Re: USACE File No. NAE-2019-02150
Remedial Activities Project
Former Tidewater Facility
200 Taft Street
Pawtucket, Rhode Island

As we have discussed during the past few weeks, GZA GeoEnvironmental, Inc. (GZA), on behalf of The Narragansett Electric Company d/b/a National Grid (National Grid), is seeking approval of certain modifications to the approved, on-going Remedial Activities at the Former Tidewater Facility located in Pawtucket, Rhode Island (herein referred to as the Site).

Given the observed coal tar impacts in certain areas, we are seeking approval to modify the revetment cap design in the northern portion of the Site between Stations 4+00 and 5+95 (approximately 195 feet along the shoreline) to minimize the disturbance of coal tar impacted soil and the risk of a potential breach in the controls (turbidity curtains and absorbent booms) installed within the river. Instead of disturbing and excavating in these impacted areas, fill consisting of stone, RCM, woven and non-woven geotextiles, and riprap will be placed on top of the surface of the impacted sediment, all below MHW and the High Tide Line (HTL). The slope of the bottom sediment will also be adjusted accordingly –

D1 WALL SECTION (STA. 5+75)
SCALE: 1" = 10'

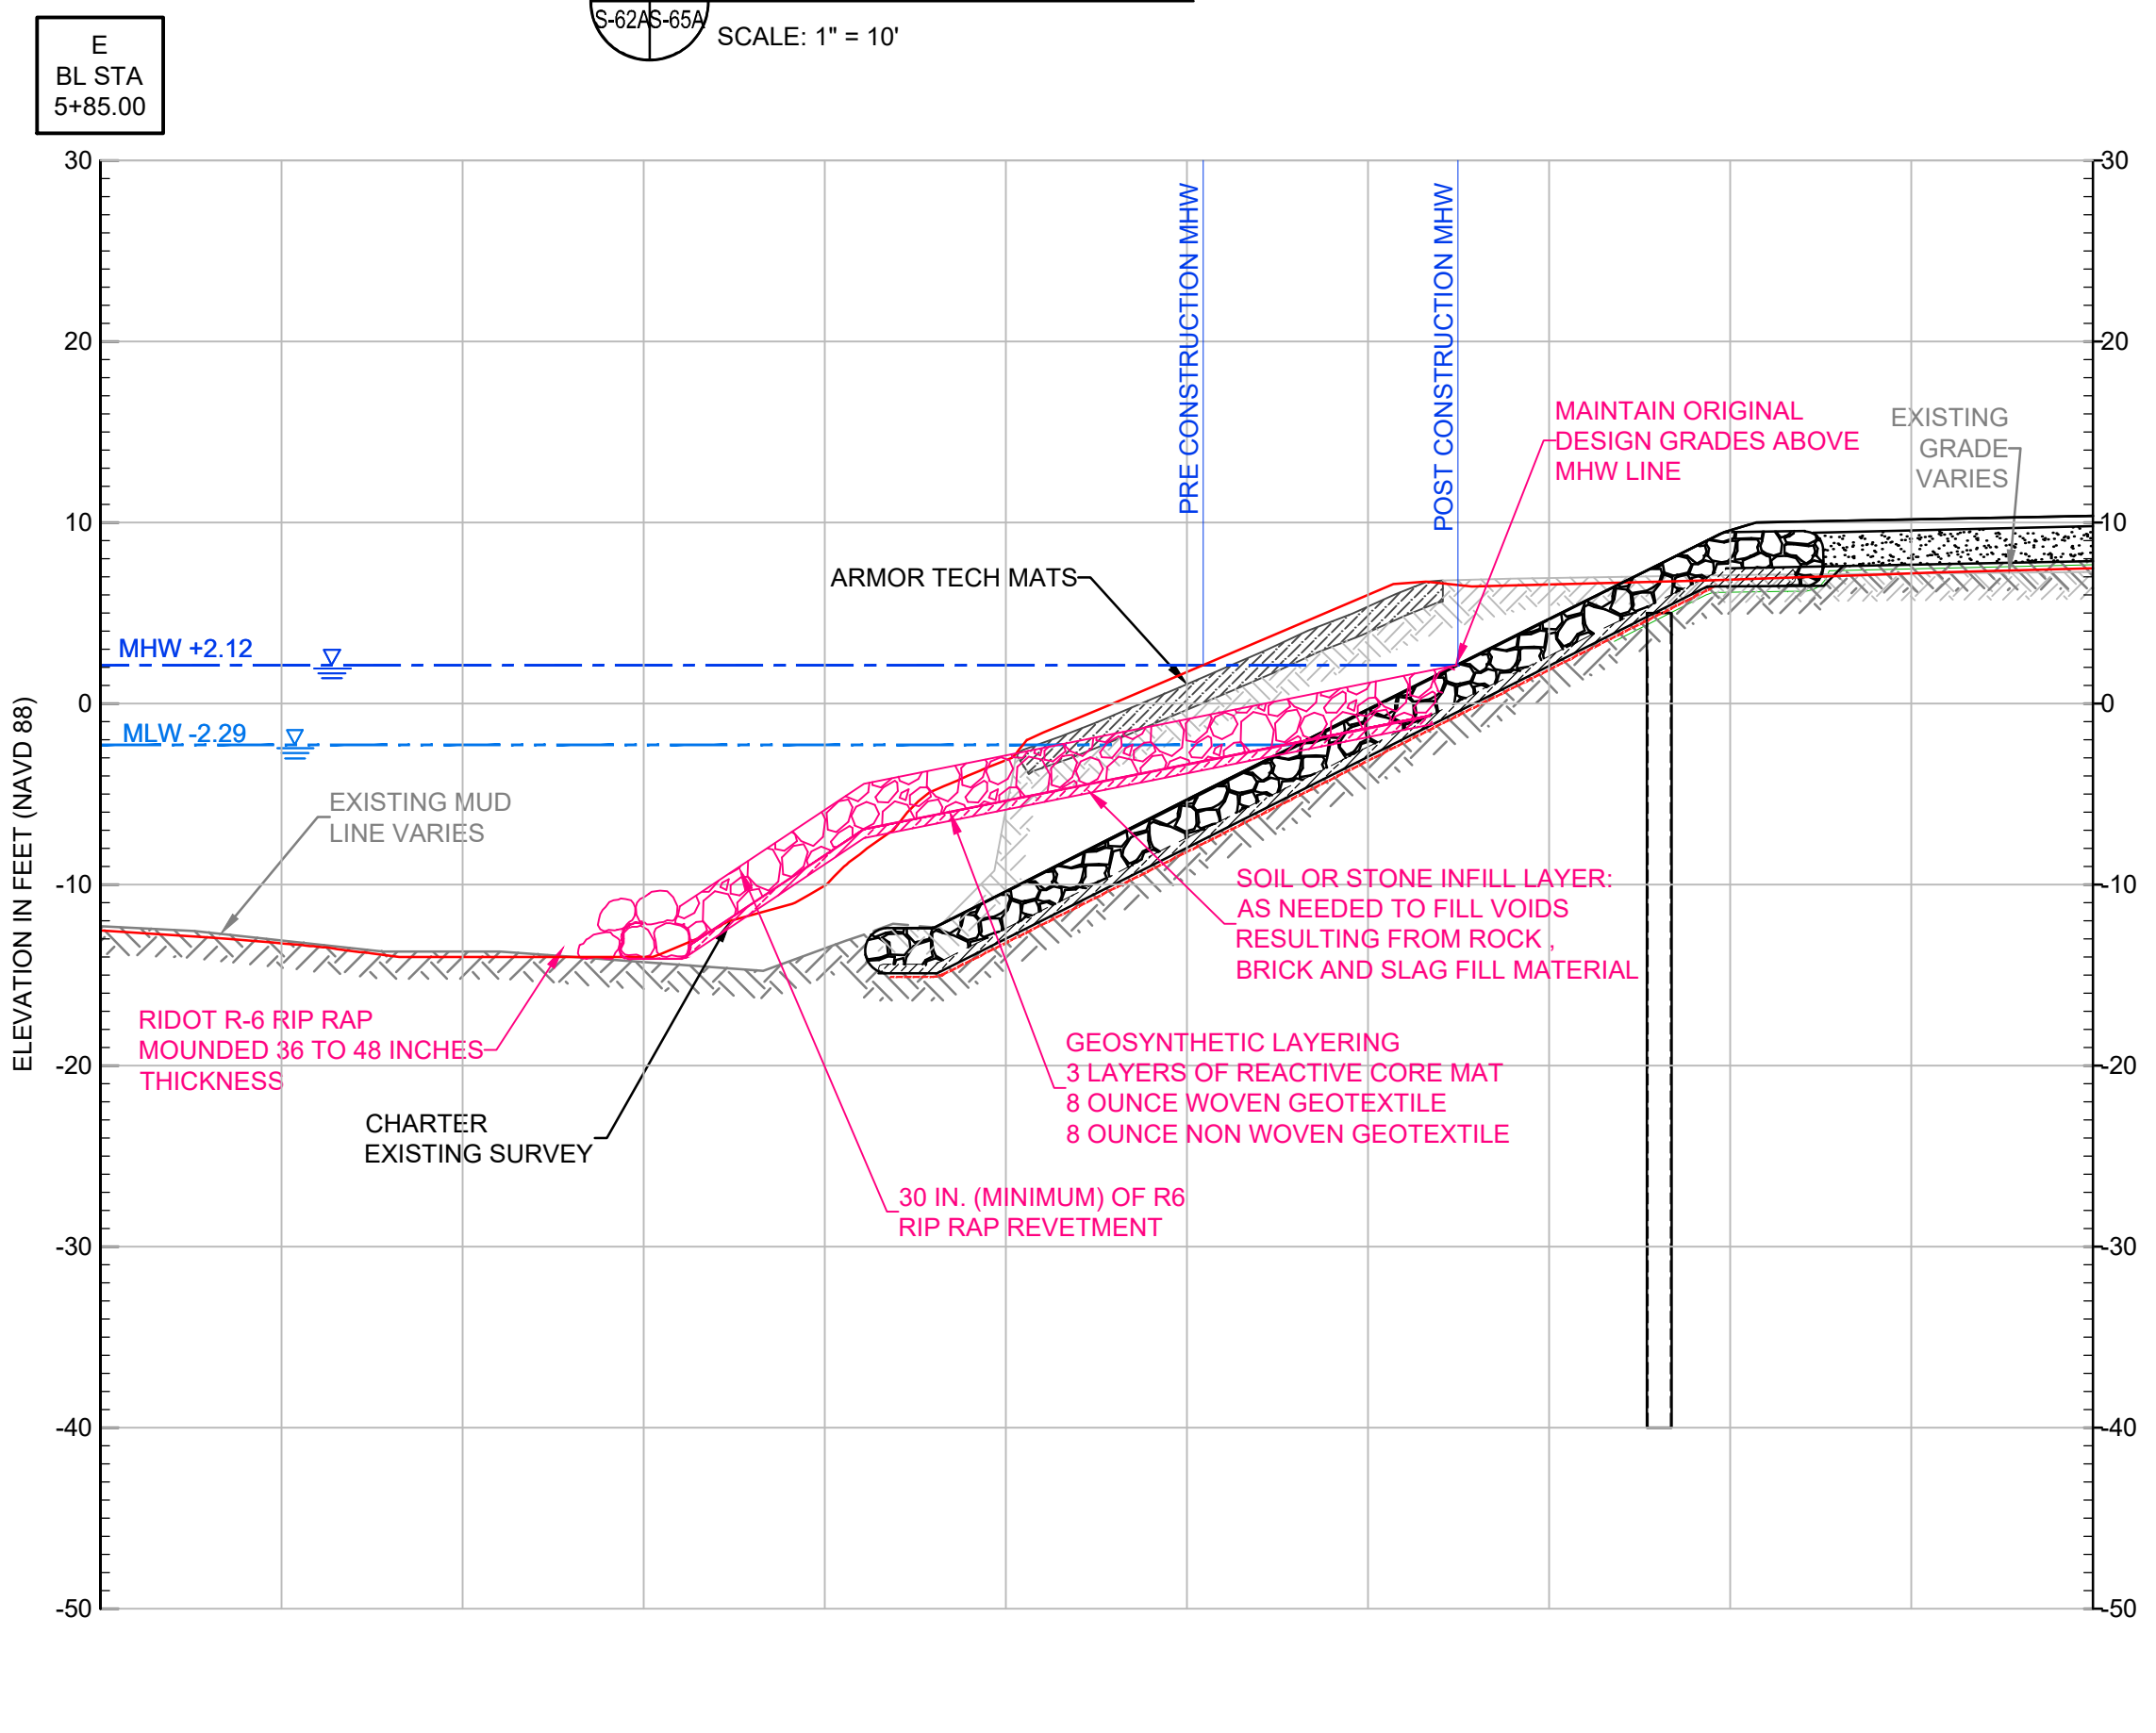
extend several feet beyond what was anticipated within the 2019 permit. The existing riverbank above MHW will be regraded consistent with the original permitted design. The final result for the overall project will be a decrease in the amount of dredged material and an increase in fill replacement compared to the approved permit values. Approximate areas and distances are as follows:
